Correcting 4 False Assumptions in PG&E's Seismic Source Characterization [2015] and Update [2024] that Caused PG&E to Seriously Underestimate Seismic Hazard at Diablo Canyon Nuclear Power Plant

2024.07.17 presentation to the Petition Review Board of the U.S. Nuclear Regulatory Commission

by Peter Bird, Professor Emeritus, UCLA
consulting to San Luis Obispo Mothers for Peace,
Friends of the Earth, & Environmental Working Group

Basemap excerpted from Plate 7-1 of Pacific Gas & Electric (2015) Seismic Source Characterization for Diablo Canyon Power Plant;
Inferred Coastline thrust fault trace (in red) added by P. Bird, 2024.06.19. Triangle symbols show direction of dip of thrust faults.

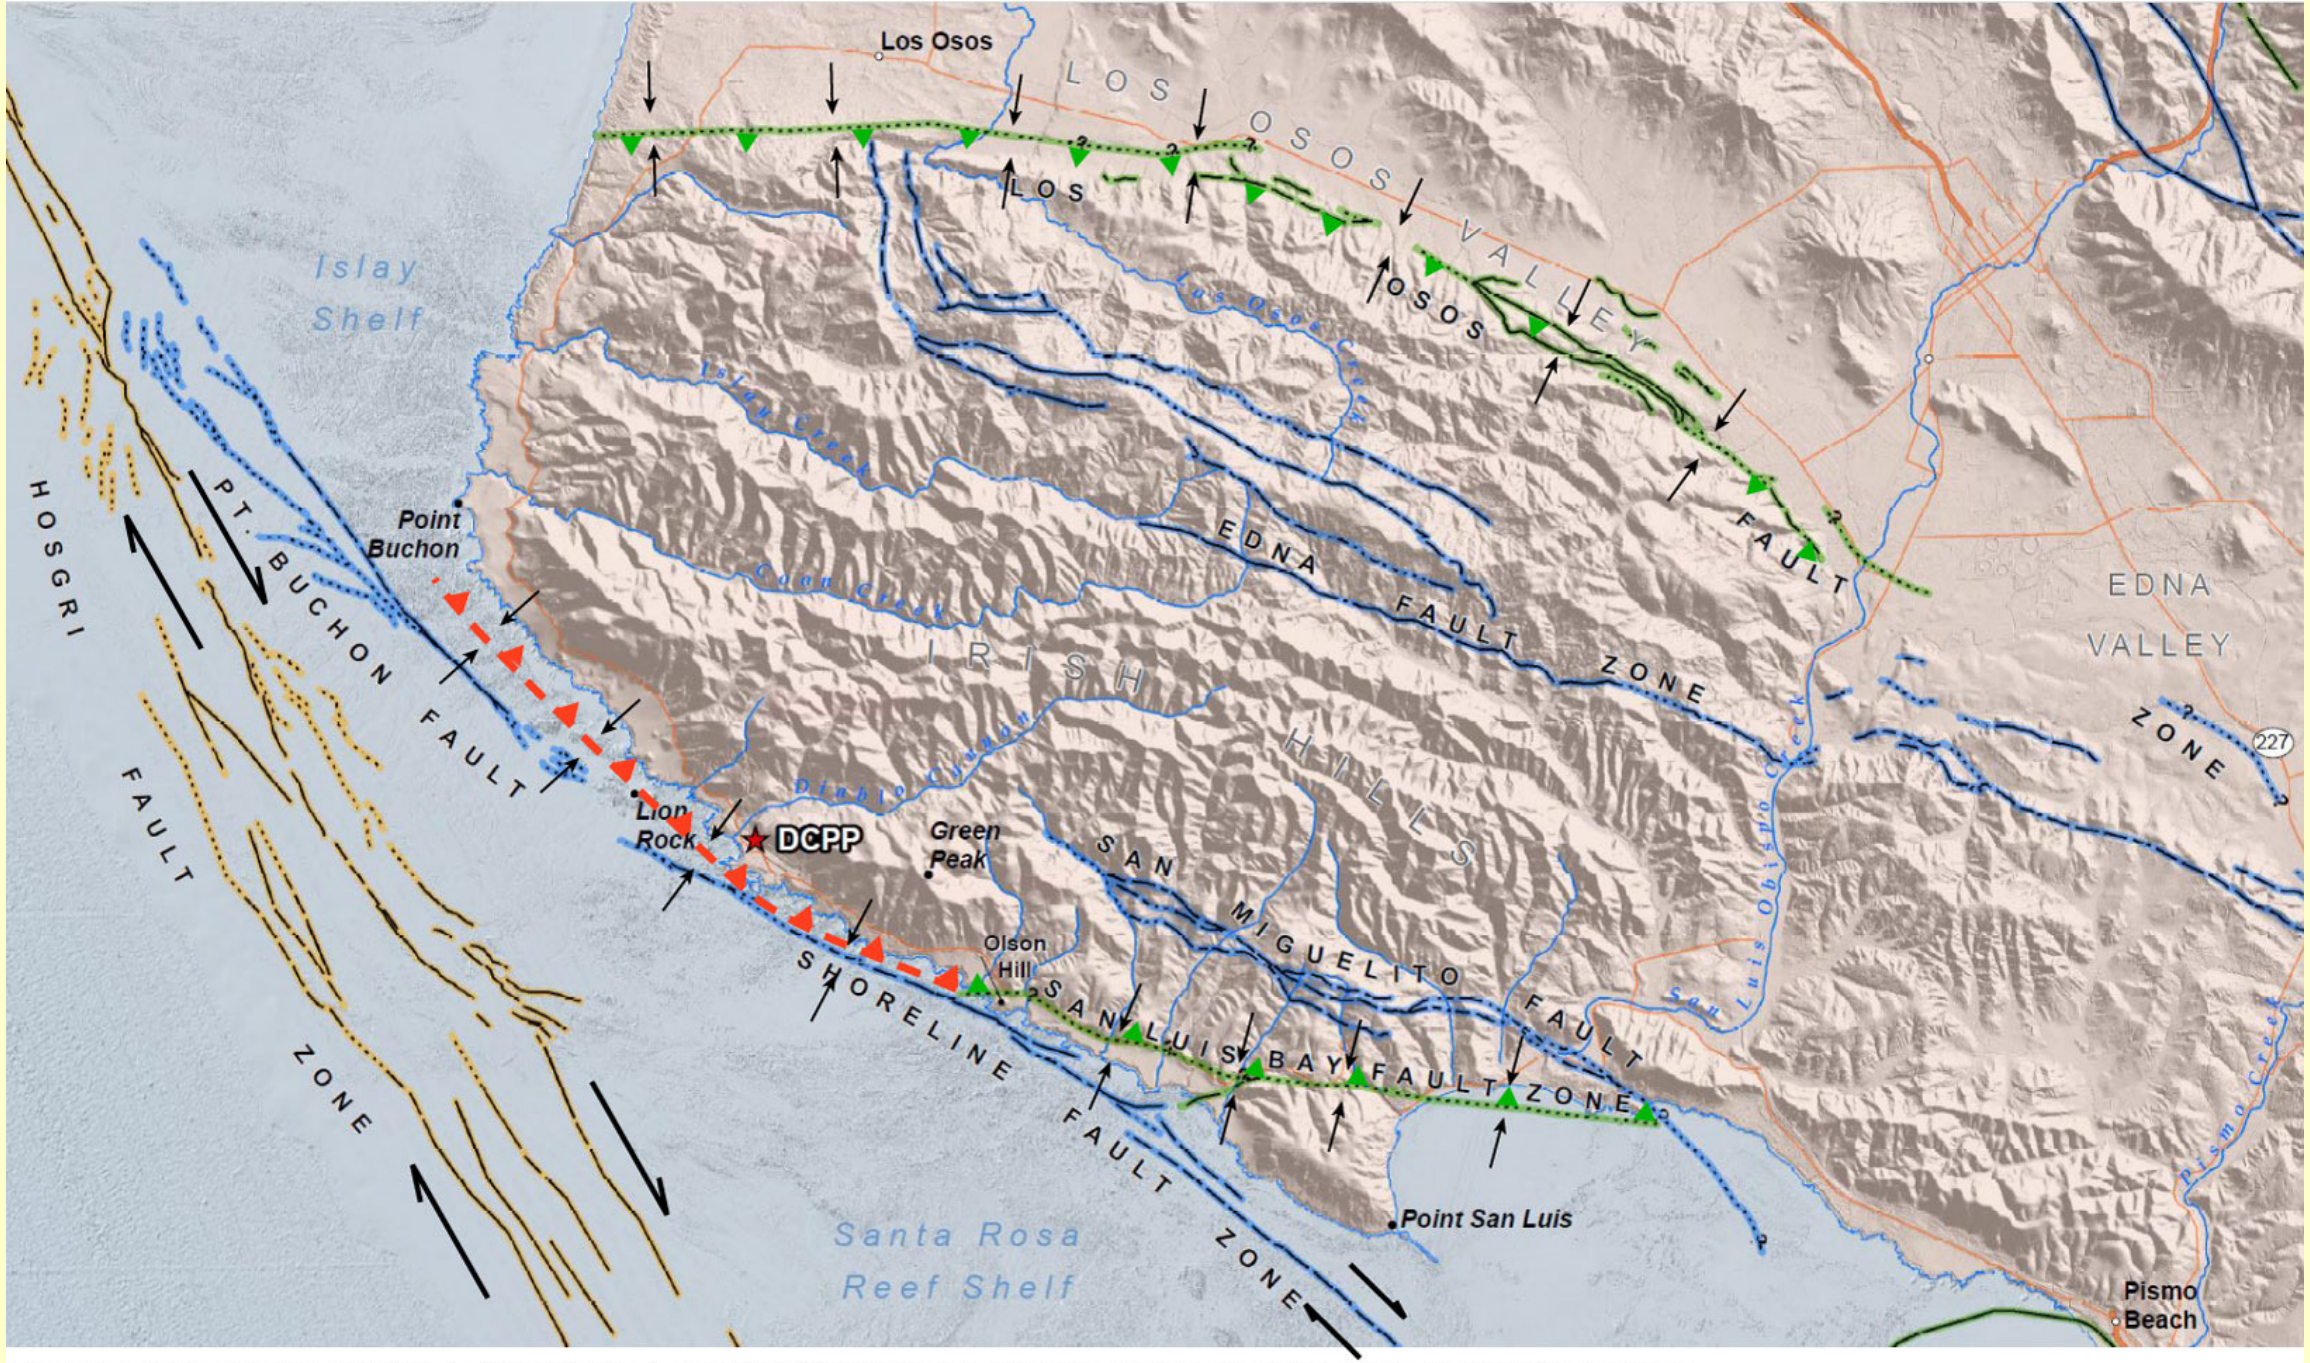
#1. The Irish Hills are uplifting (at ~0.2 mm/year, stipulated) as a rigid block, with no internal deformation.

Therefore, thrust faulting occurs only at the margins (Los Osos thrust, San Luis Bay thrust, ?Inferred Coastline thrust?) with fault throw (vertical) rates of ~0.2 mm/year.

- The geologic map shows tight folding of Late Miocene sedimentary rocks has occurred since 6~5 Ma. Therefore, the Irish Hills are <u>not</u> rigid, and additional blind thrust faults are active in the interior.

A simple isostatic model for the total rate of thrust-fault slip under the Irish Hills is at least:

$$(0.2 \text{ mm/year uplift}) \times 6 / \sin(25^\circ \text{ dips}) = 2.8 \text{ mm/year}$$

PG&E [2014]

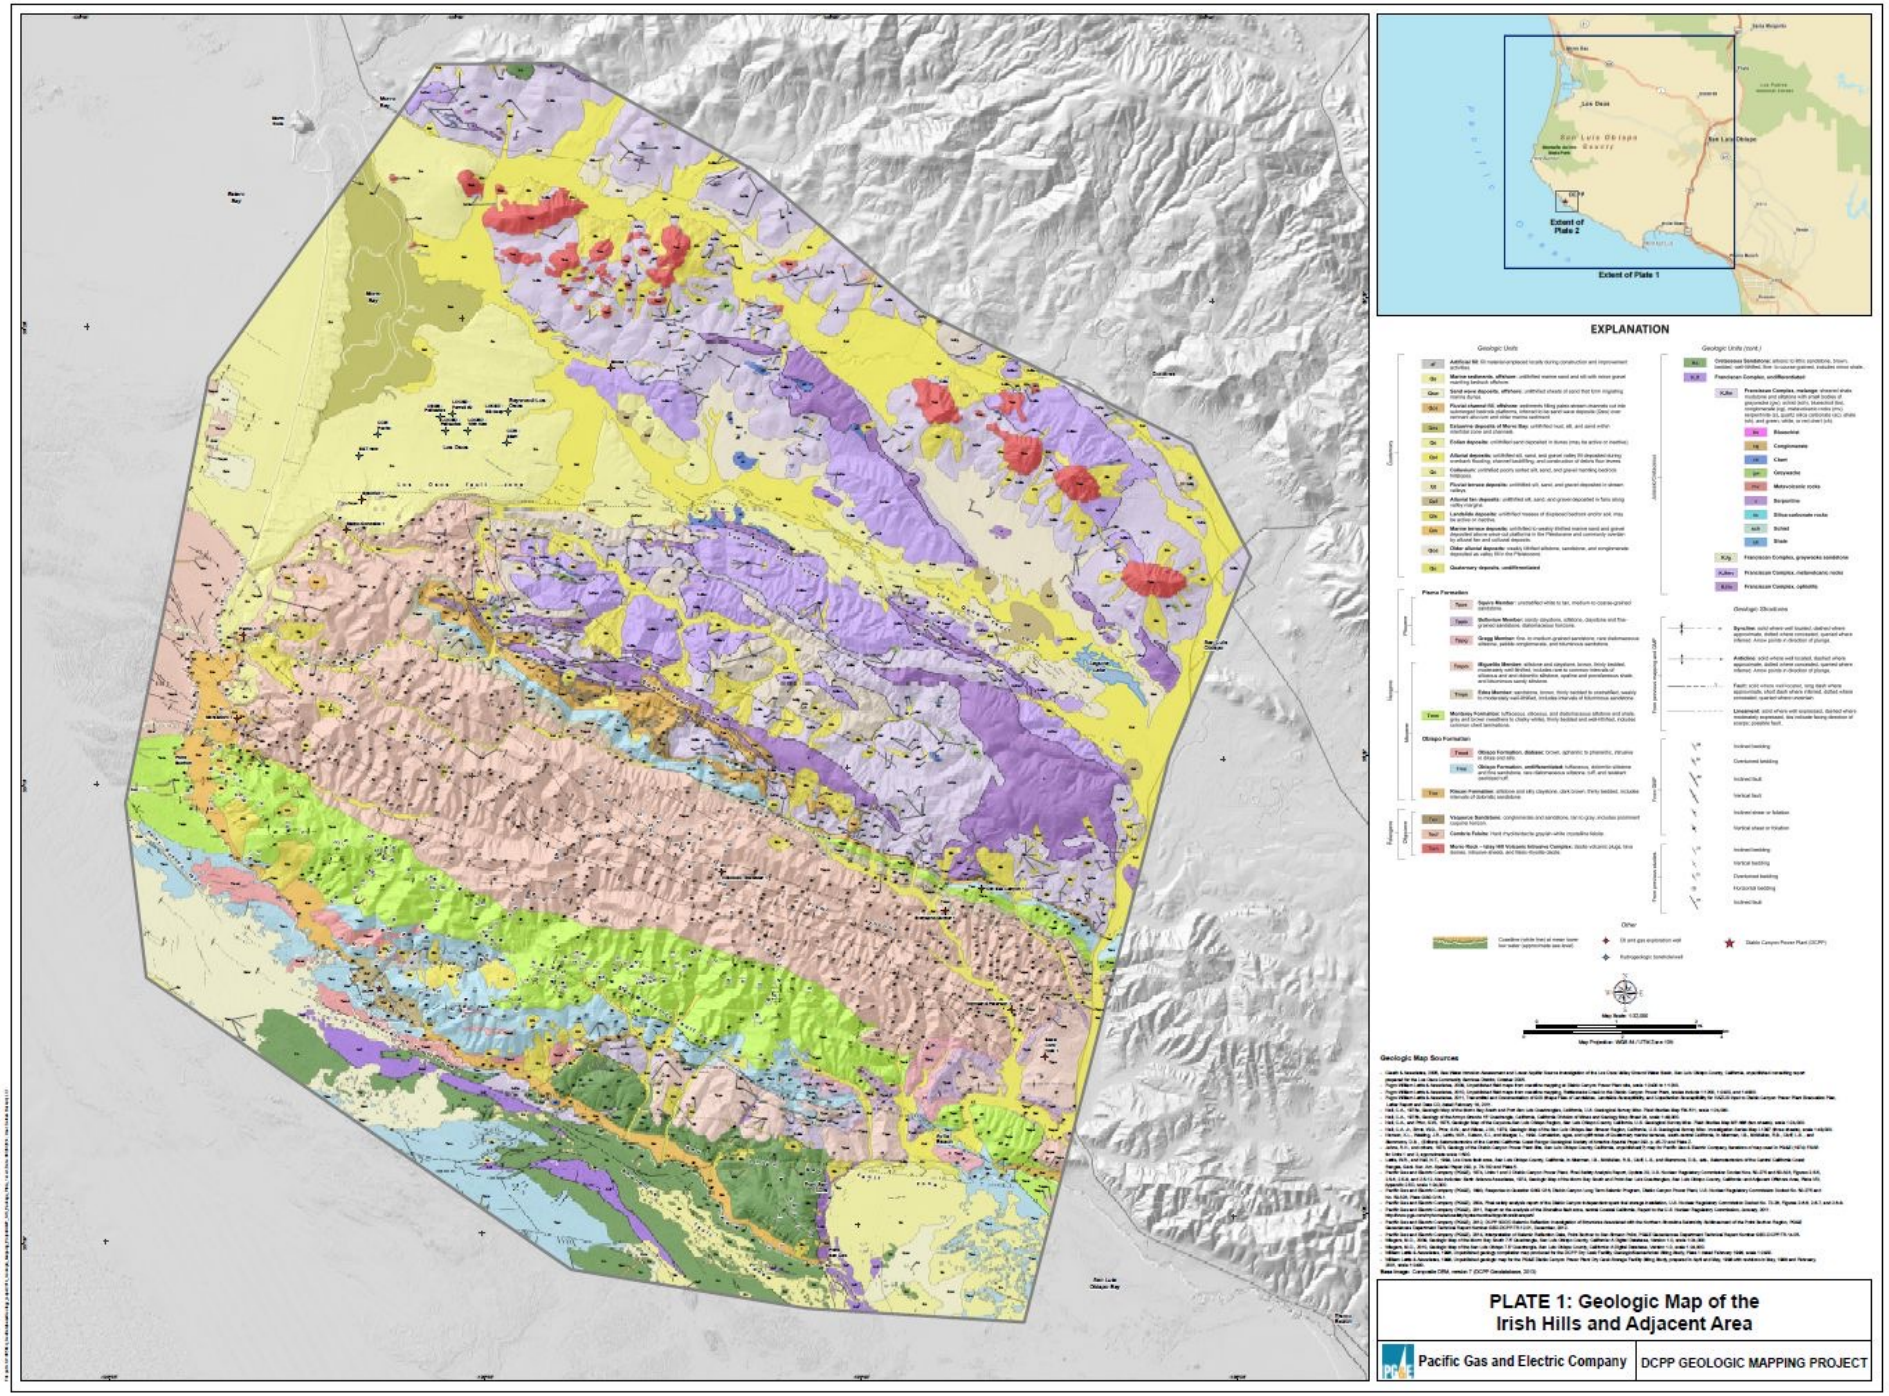
- The geologic map shows tight folding of Late Miocene sedimentary rocks has occurred since 5 Ma. Therefore, the Irish Hills are <u>not</u> rigid, and additional blind thrust faults are active in the interior.

The geologic map of the Irish Hills demonstrates large internal deformation since 5 Ma, especially in the Pismo Syncline.

Figure 6-2. Large-Scale Residual Isostatic Gravity Anomaly Map Showing a Negative Gravity Anomaly Coincident with the Irish Hills (modified from Langenheim et al., 2008 and PG&E, 2011, Figure E-2)

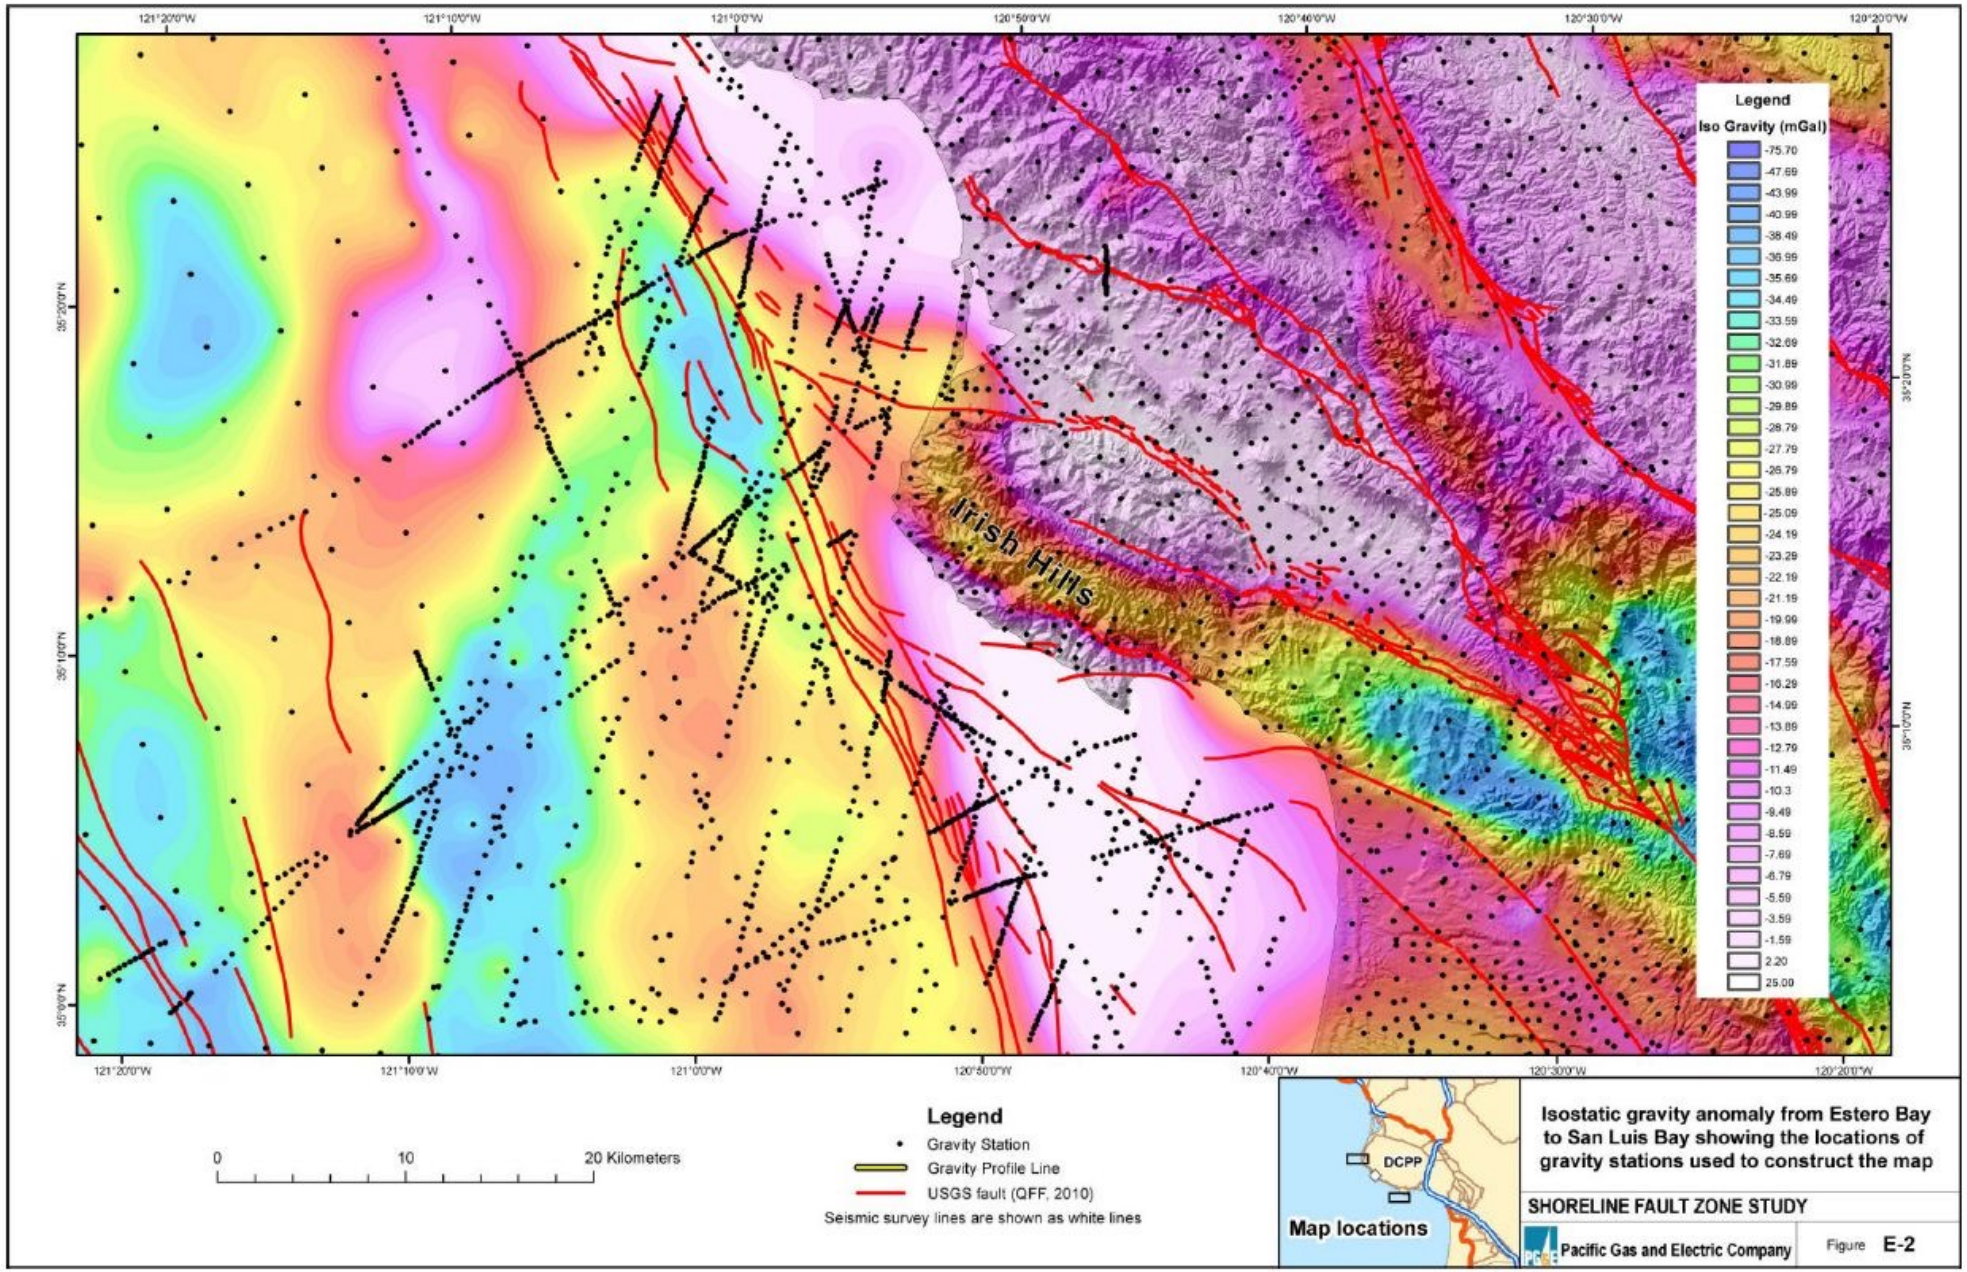
- Rigid-body uplift does not produce crustal thickening. Therefore, if the Irish Hills were a rigid block, they would have a <u>positive</u> isostatic gravity anomaly. However, data shows a <u>negative</u> isostatic gravity anomaly, indicating <u>more</u> than simple Airy compensation by crustal roots (more than the typical Airy ratio of 6:1).

The negative isostatic gravity anomaly here means that:

The topography of the Irish Hills is not just isostatically compensated, it is OVER-compensated by crustal thickening.

A simple isostatic model for the total rate of thrust-fault slip under the Irish Hills is at least:

$$(0.2 \text{ mm/year uplift}) \times 6 / \sin(25^\circ \text{ dips}) = 2.8 \text{ mm/year}$$

Figure 5

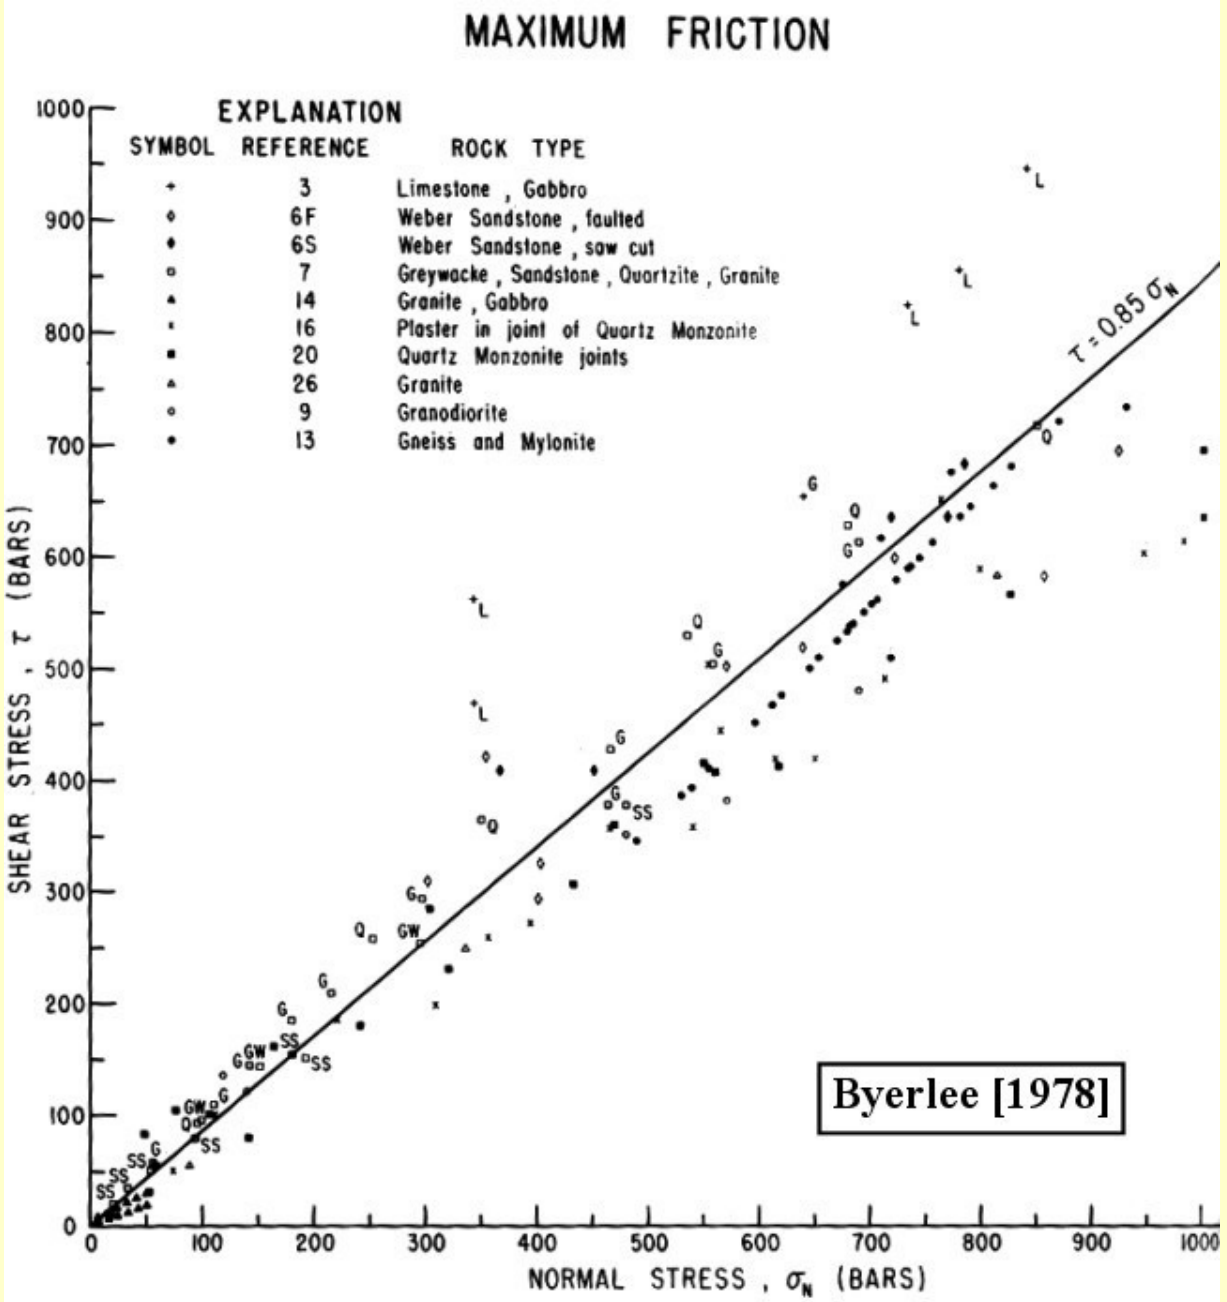
PG&E assigned alternative model dips of 30°, 50°, and 80° for the Los Osos thrust fault, and 45° to 75° for the San Luis Bay thrust fault.

125-year-old Mohr/Coulomb friction theory shows that thrusts never form at dips steeper than 45°, and most commonly dip at ~25° [for rock friction coefficient of 0.85; *Byerlee*, 1978].

Compared to reasonable estimates (obtained with dip of 25°), an assignment of 50° dip reduces seismic potency rate by a factor of **3.3×**. An assignment of 80° dip reduces seismic potency rate by factor of **5.4×**.

Thus, PG&E underestimated seismic potency of these 2 thrusts (which were the only ones they recognized) by large factors.

Seismic potency rate (per m of fault trace) is defined as = (slip rate) × (down-dip width).

This important measure of earthquake generation varies as $1/\sin^2(\text{dip})$ when throw-rate is held constant (as in these 2 SSC studies).
